Job Name:	Lotmead Farm Villages
Job No:	27970
Note No:	27970/4003/TN001
Date:	22/08/19
Prepared By:	R Laker
Subject:	Addendum to March 2019 Flood Risk Assessment

Job Name:	Lotmead Villages, Swindon
Job No:	27970/4008
Note No:	TN201901
Date:	14/08/19
Prepared By:	S Bari
Subject:	Response to EA model review ref 2018s0387

Appendix B Surface Water Drainage Strategy

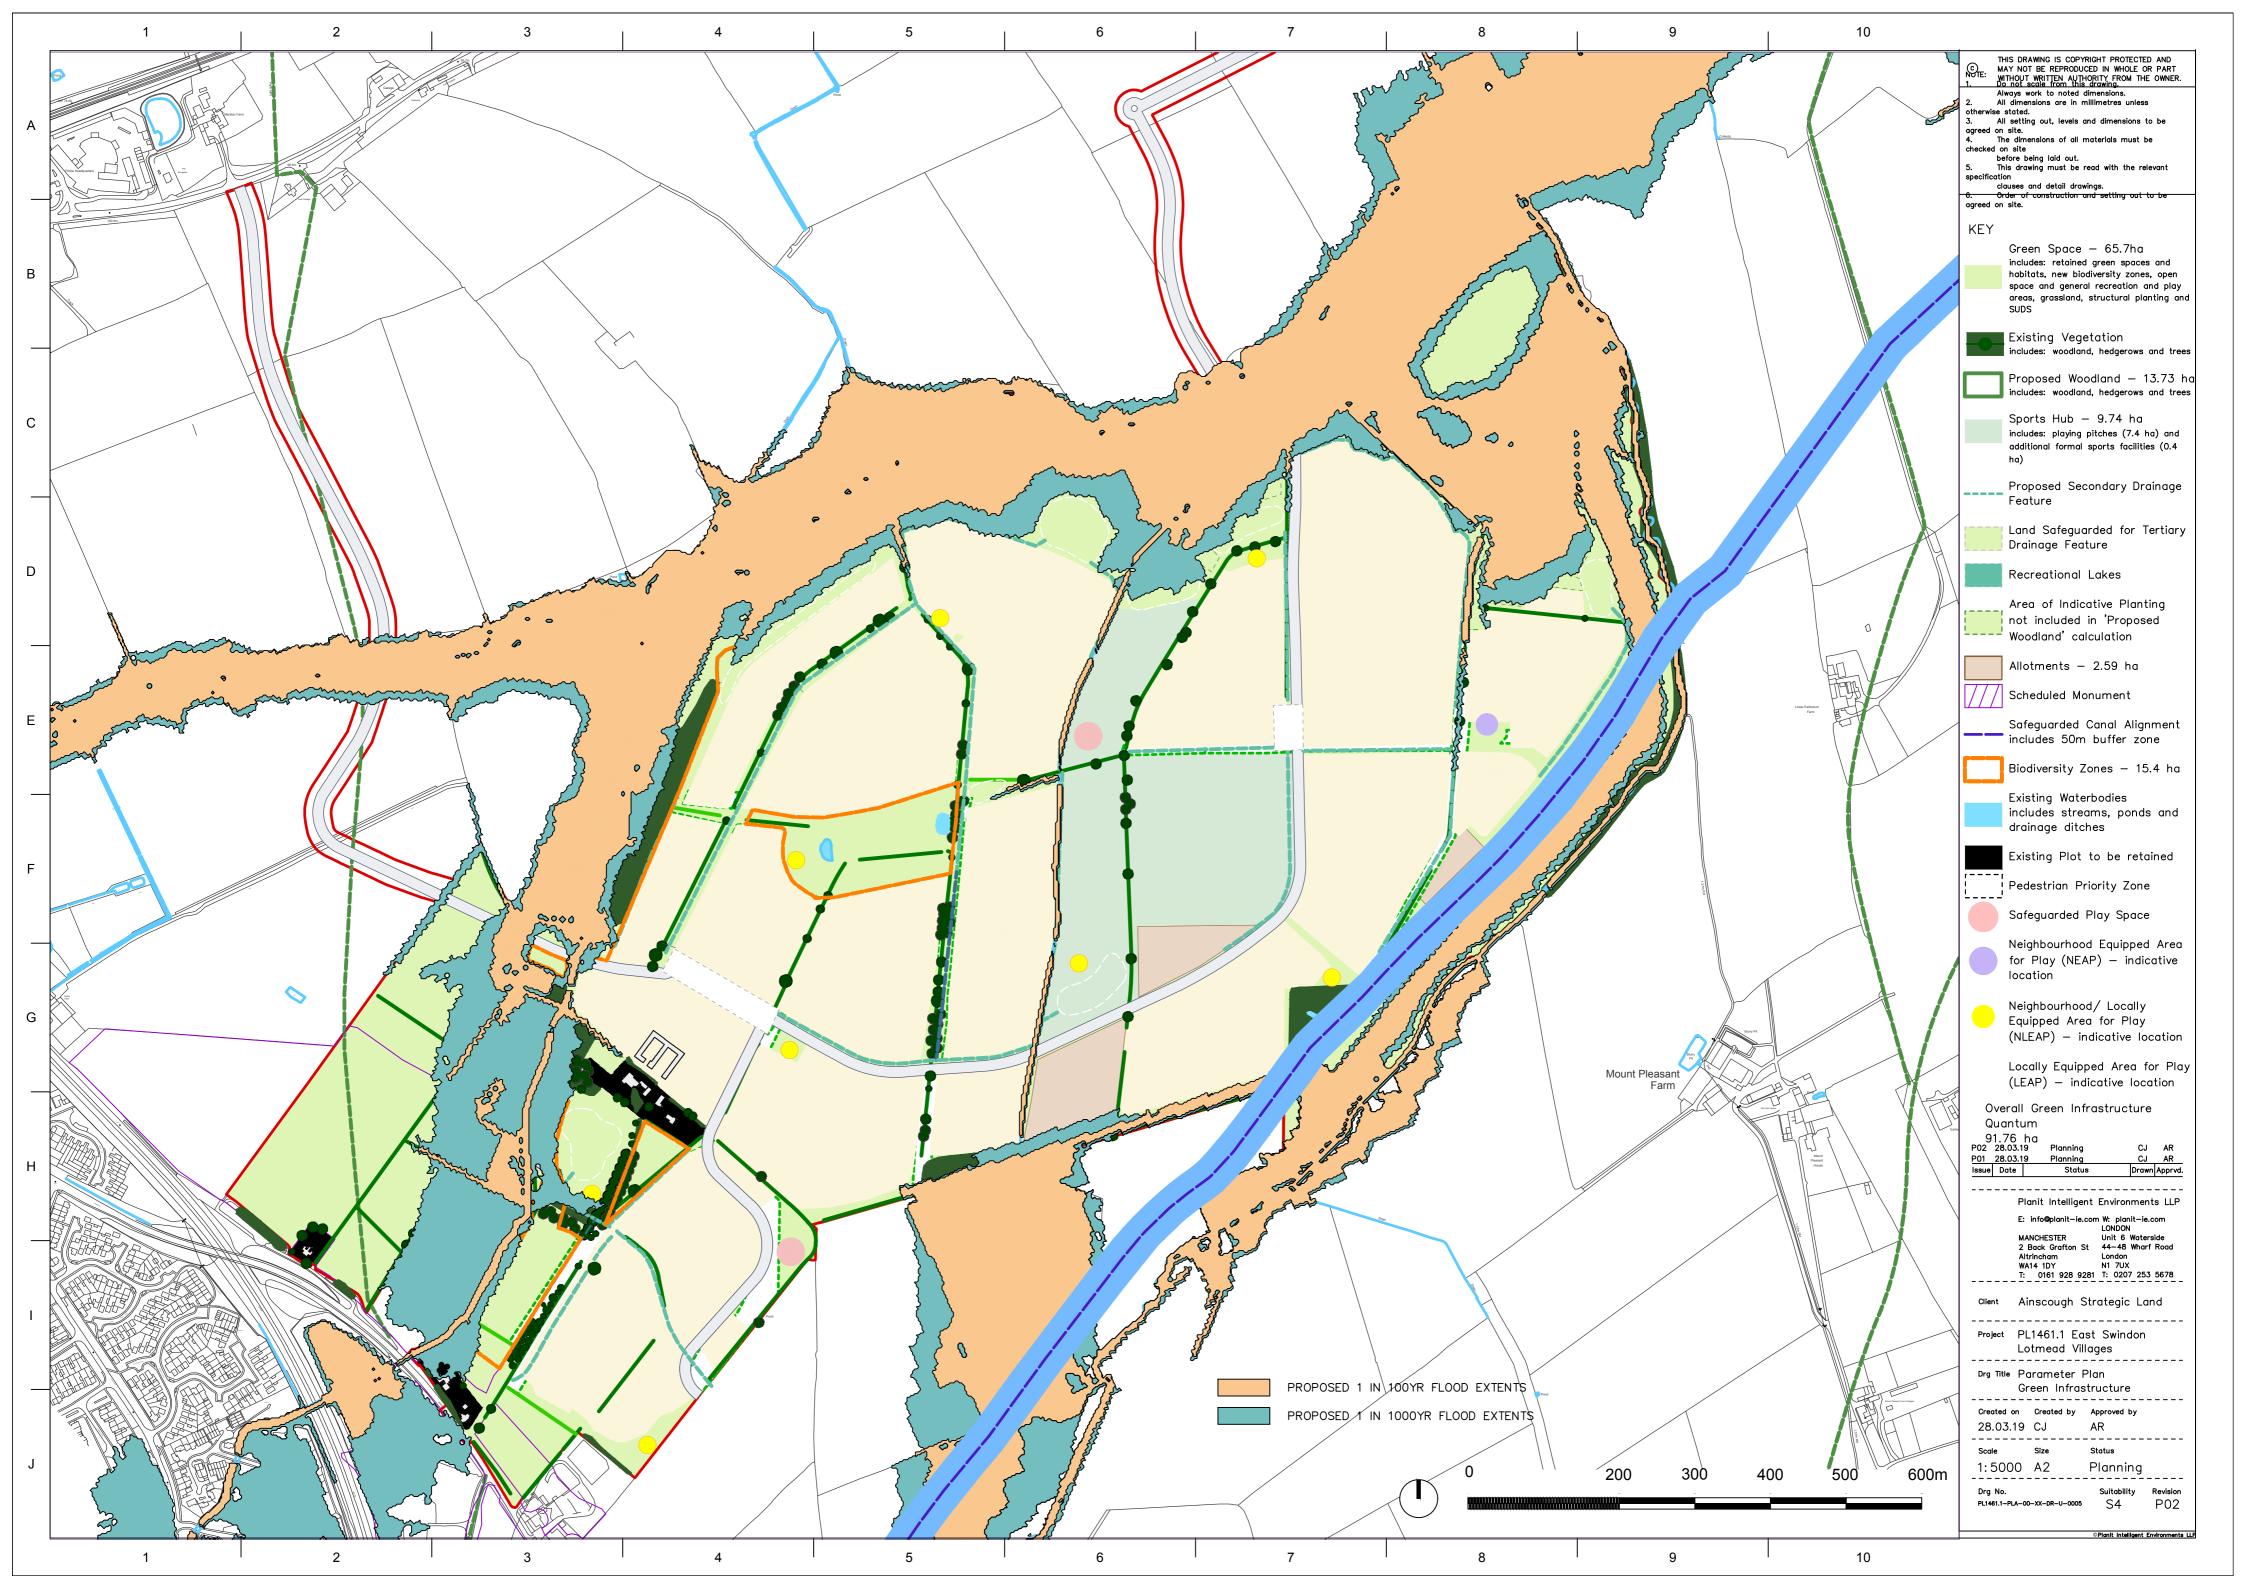
The surface water drainage strategy presented in the FRA is one potential solution, however, this was considered by SBCs drainage engineer to be overly reliant on tertiary drainage measures and as such, revised calculations and drawings have been provided which incorporate reasonable assumptions to the provision of on-plot source control measures.

The catchment areas have been amended as per PBA Drawing 27970-4005-001 Rev B. It is expected that the intermediate discharge rates will vary as detailed designs are prepared at a later stage to suit evolving designs for SuDS features however, the overall discharge rate will still be limited to 4.67 I/s/ha, and is anticipated to be distributed across a number of catchment areas across the site through the indicative allowable discharge rates as per Table 1 below.

SBC's drainage engineers approved the revised drainage strategy through email correspondence on 19th July 2019, stating that the revisions had gone a long way in addressing their comments, subject to a few minor outstanding amendments. All amendments have now been completed and incorporated into this addendum.

Figure 1) Downstream boundary location

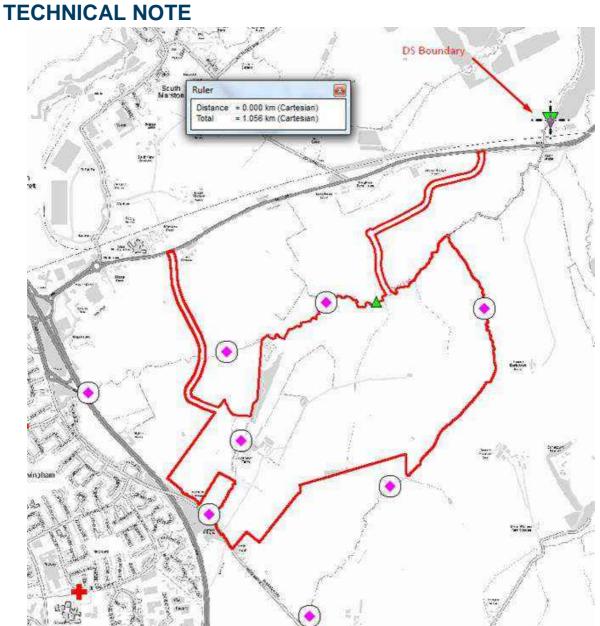
'Coincidently whilst checking the HQ was sufficient for the +70% CC flows it has been noted it has been applied incorrectly. Flow should be in the first column of the curve and stage in the second. See output from the 1d_bc check file. As such, the stage at the downstream node of the model is set at the bed level of cross section.'

- 2.2. The reviewer's comments are correct. This error was present in the original EA hydraulic modelling and unfortunately, was not identified during our update. Our modelling did not look to alter the downstream boundary conditions from the original calibrated EA model so we were not alerted to this discrepancy at the time.

- 2.3. As the downstream boundary condition in the model is set to the bed level of the channel rather than using the HQ rating curve, this would lead to a local drawdown in the modelled flood level at the downstream of the model.

- 2.4. However, having reviewed the model, the 1d downstream boundary condition has only a negligible impact on the modelled water levels at the site for the following reasons.

- The downstream boundary is located over 1 km downstream of the site it is unlikely that any drawdown effect would extend this far upstream.
 - The boundary is located behind two significant flow control structures across the floodplain the A420 road and the railway line. These would act as a downstream control and prevent any artificial drawdown of flood levels at the downstream boundary extending further upstream to the site.

- 2.5. **Figure 1.** below indicates that location of the site and the downstream boundary and shows the downstream boundary is over 1 km away from the site.

Figure 5) EA model inflow boundaries

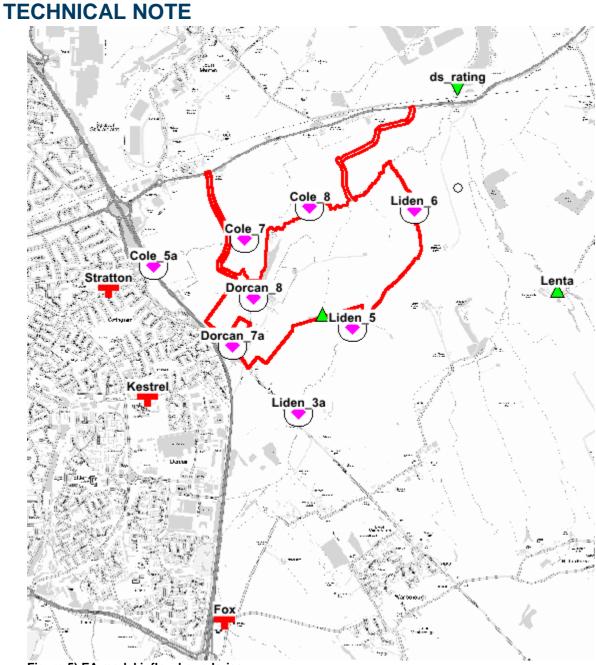
'It should be noted that in the bc_dbase an inflow named "ditchA" is present for both the 100-year + 35% climate change and 100-year +70% climate change events bc_dbases but isn't in the inflow CSV's. Additionally, "Input_G_Lta" is noted in the inflows CSV but not in the 1D QT boundaries. Should these flows be applied?'

3.4. Input_G_Lta was included in the flow data .csv file from the EA model however it was not used in the their final model. **Figure 5.** shows the inflow labels from the EA model (1d_bc_swin_077), which does not include Input_G_Lta. Therefore the omission of this inflow is consistent with the existing EA model.

3.5. As such the comments on the inflow boundaries do not need to be considered further.

Figure 6) Location of messages

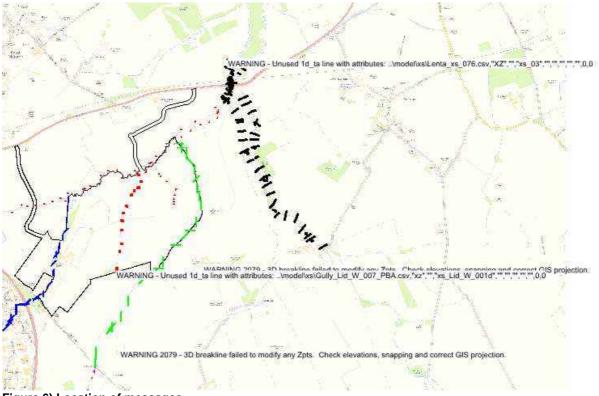
- 5.1. The final comments from the model review were Green comments;
- 5.2. By definition these comments are not considered significant in terms of influencing the model results.
 - "WARNING Unused 1d ta line with attributes: ..\model\xs\Lenta xs 076.csv"
 - "WARNING Unused 1d_ta line with attributes: ..\model\xs\Gully_Lid_W_007_PBA.csv"
 - "WARNING 2079 3D breakline failed to modify any Zpts. Check elevations"
 - "WARNING 2079 3D breakline failed to modify any Zpts. Check elevations"
- 5.3. PBA has investigated the locations of these messages. **Figure 6.** shows the locations of these messages.

Figure 9) EA 1000 year dVol and Cumulative Mass Balance Error (%)

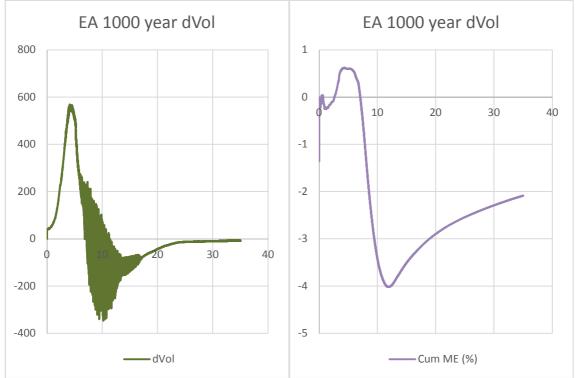
'DVol for both runs has a sensible profile but notable oscillations. The reviewer has looked at the results in the 1D domain in the vicinity of the site and from a random inspection there does not appear to be any significant oscillations in either flow or stage within the vicinity of the proposed development. Potentially, this is an issue with another part of the model. Without model results from the original model the reviewer cannot determine if this is something caused by the climate change inflows or the original model.'

6.2. This comment is not considered significant, the reviewer indicates that this is likely to be a legacy issue within the EA model and does not influence the model at the site. **Figure 9.** shows the EA dVol and cumulative ME for the 1000 year results, which indicates similar profiles and oscillations as PBA's models.

6.3. The oscillations in dVol and the cumulative Mass Balance Error (%) in the PBA modelling have been inherited from the EA model, consequently, it is considered that this comment does not need to be addressed further.
